Technical Service Bulletin

Cobra Motorcycle Mfg.

TSB0611 2010 CX65 Cylinder and Head Insert

Part numbers

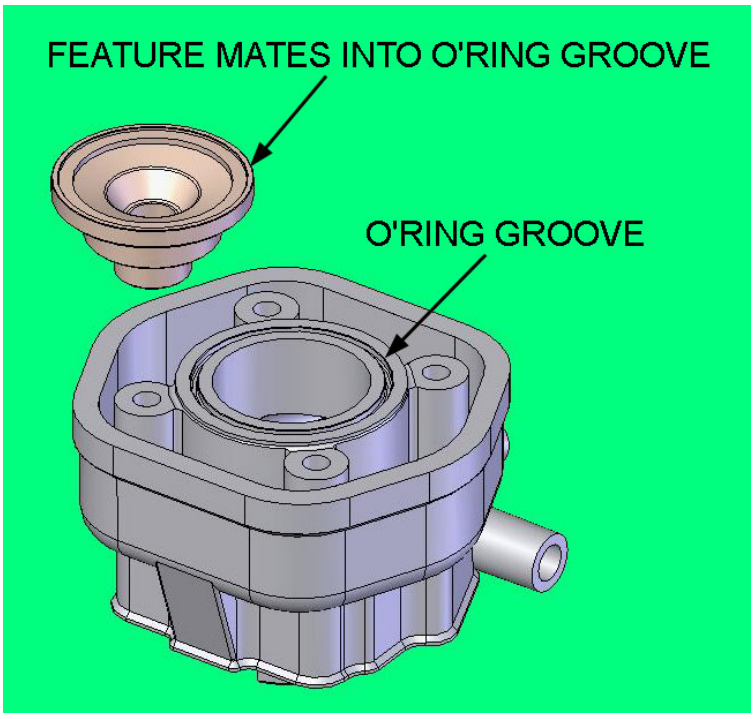
On the 2010 CX65 it is possible for the ‘self piloting ‘cylinder and cylinder head to be off center (non-concentric) enough for the piston to contact the head insert. Cobra has come up with a solution for this which requires a new cylinder head insert and machining to the customer’s cylinder. Cobra will perform this machining for $25 if the cylinder is sent to the factory. New style cylinder head inserts are available.

New	Old
Head Insert	ECC60073	ECC60036
O’Ring	ZCMUOR05	ZCMUV032
Cylinder Kit	ECC60075	ECC60037
